9.4 Air Conditioning, Heating, Cooling and Ventilating Systems

The information in this section of the reference ABWR DCD, including all subsections, tables, and figures is incorporated by reference with the following departures and supplements.

Figure 9.4-2c ~~Electrical Building HVAC System Diagram~~
Turbine Building Electrical Equipment Areas (EEA) HVAC System Diagram

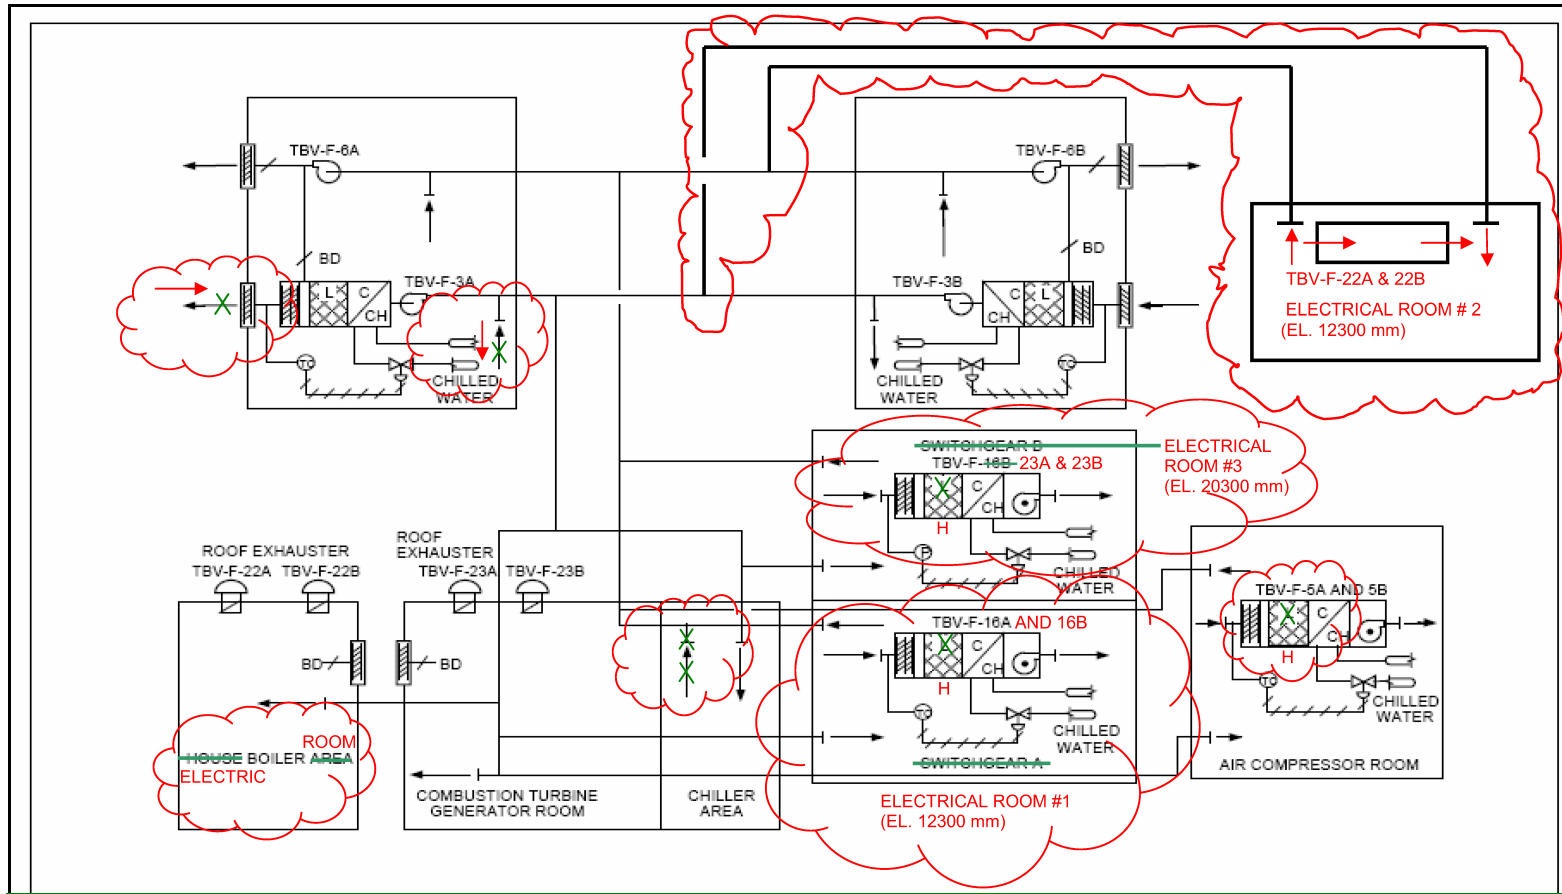
STD DEP 9.4-4 (Tables 9.4-3, 9.4-5, 9.4-5a, 9.4-5b, 9.4-5c, and 9.4-5d), (Figures 9.4-2a, 9.4-2b Sheet 2, and 9.4-2c)

The ~~E/B~~ EEA HVAC schematic diagram is shown on Figure 9.4-2c.
